Memorandum

Re: Village Board Meeting – Paragon Mechanical LUV Amendment (PC 22-010), 2400 S. Arlington Heights Road

VILLAGE RECOMMENDED ALTERNATIVE

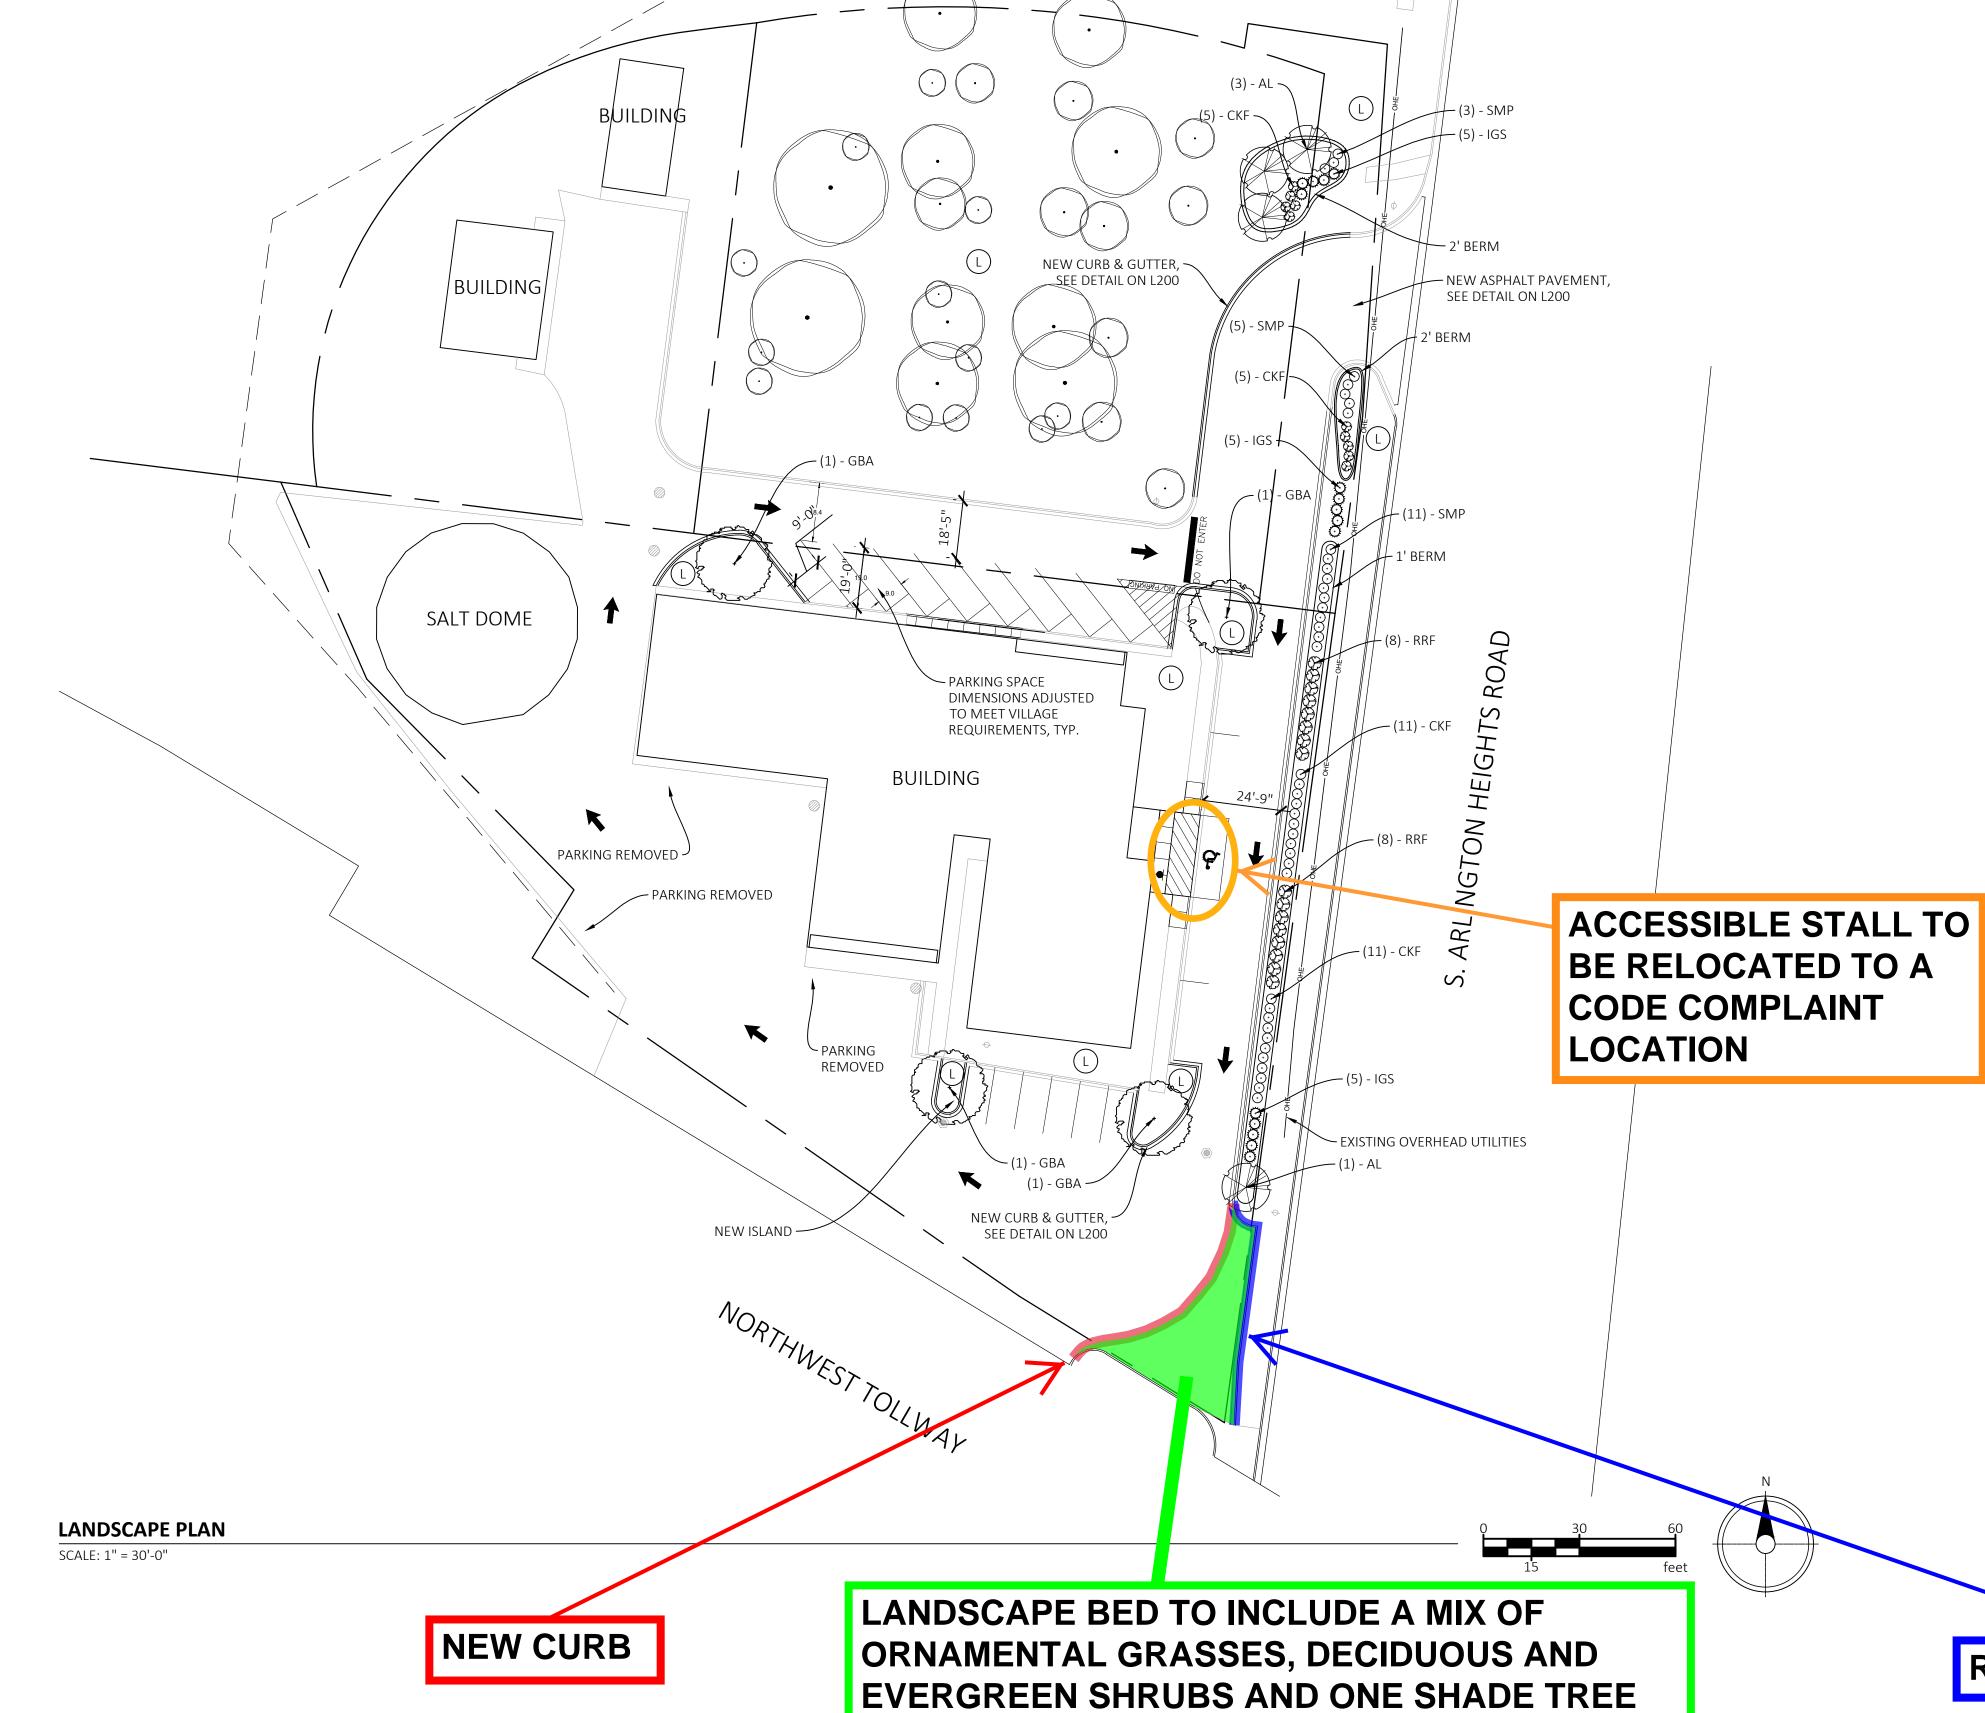
The staff recommended alternative is attached to this memo as "Village Recommended Alternative". This plan was prepared by Paragon based on discussions with staff. It should be noted that Village staff is recommending the following modifications to the plan, which are noted below and also highlighted in color within the plan:

- The southern corner of the site shall be improved with a cubed landscape island including a mix of ornamental grasses, deciduous and evergreen shrubs, and one tree.
- The proposed parallel handicap parking stall is not compliant with IAC accessibility regulations. This parking stall shall be relocated to a code-compliant location.

- 2. This approval shall be conditional upon compliance with the following additional strictions:
 - a. Condition #3 of Ordinance 20-022 shall be modified to require the petitioner to construct and complete the site modifications and landscaping as depicted in the **Village Recommended Alternative**.

- b. All sitework and landscape work must be completed no later than May 31, 2024.
 - c. Prior to adoption of an Ordinance authorizing this amendment, the Petitioner shall provide a performance guarantee for completion of the work.

PARAGON PROPOSED ALTERNATIVE A

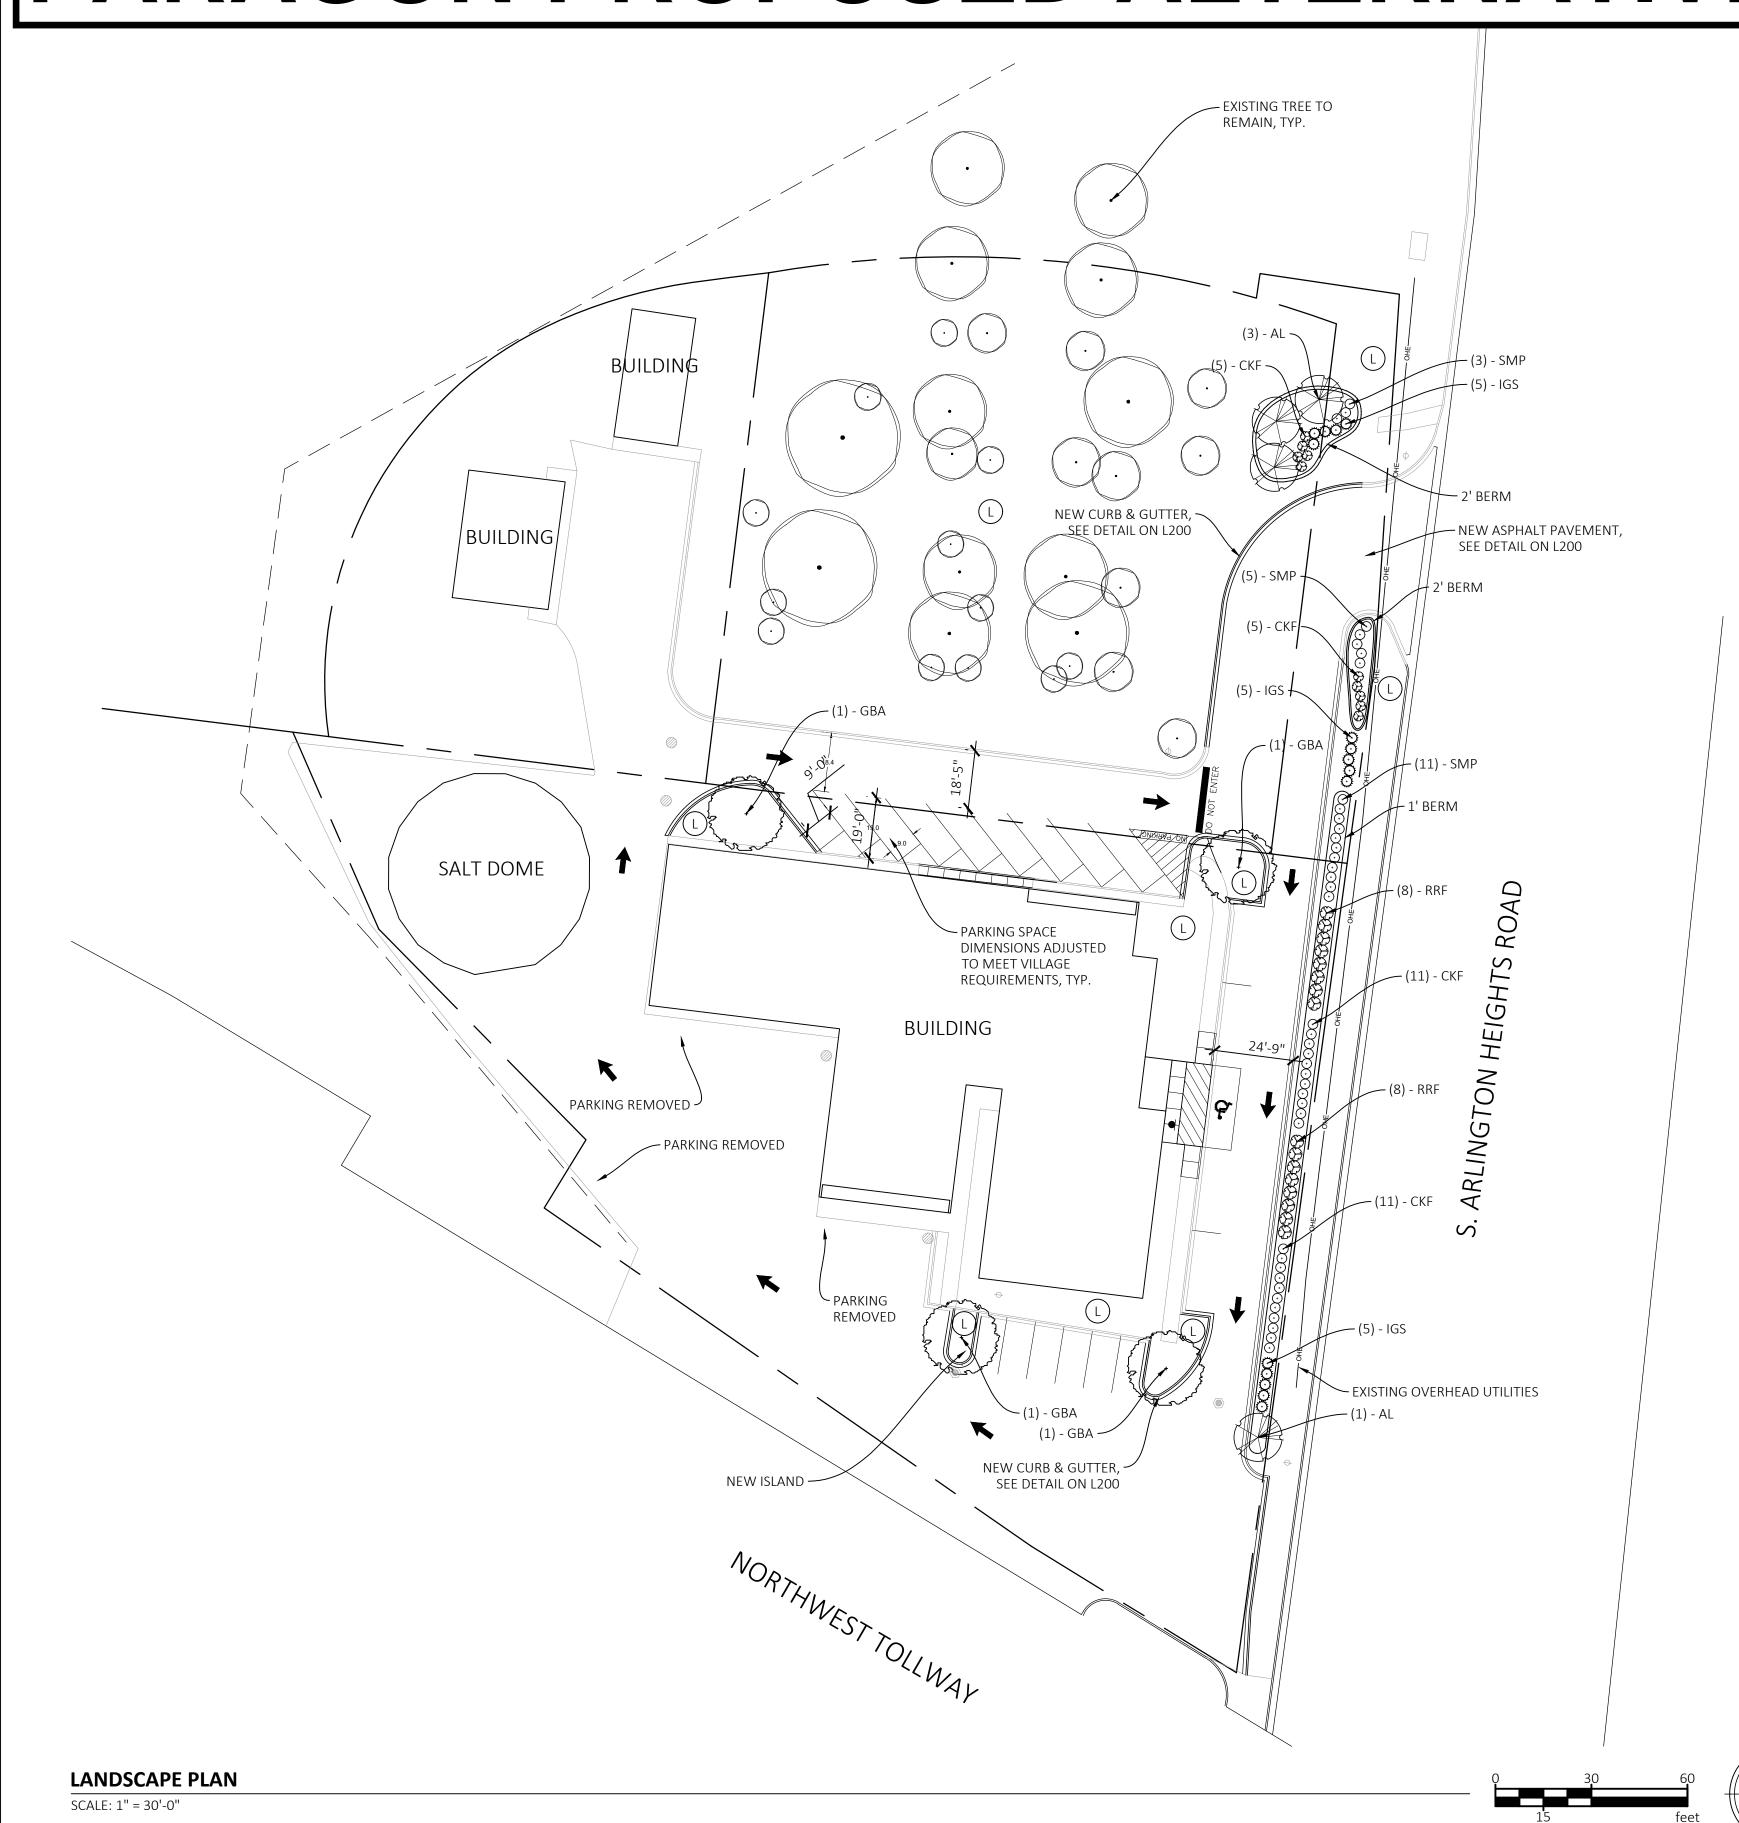
Paragon has proposed an alternative landscape plan for consideration by the Village Board, which is attached to this memo as "Paragon Proposed Alternative A". This plan is identical to the staff recommended alternative, with exception to the colorized modifications as shown on staff's plan. Paragon is only willing to implement their plan should condition #8 be eliminated and the Land Use Variation be granted with no expiration date, and they have stated that they are not willing to provide a bond for this work. The petitioner has not provided a date for when this work would be completed. It should be noted that in order to comply with code requirements, a code compliant ADA parking stall would be required since the proposed parallel ADA parking stall does not comply with Illinois Accessibility Code regulations.
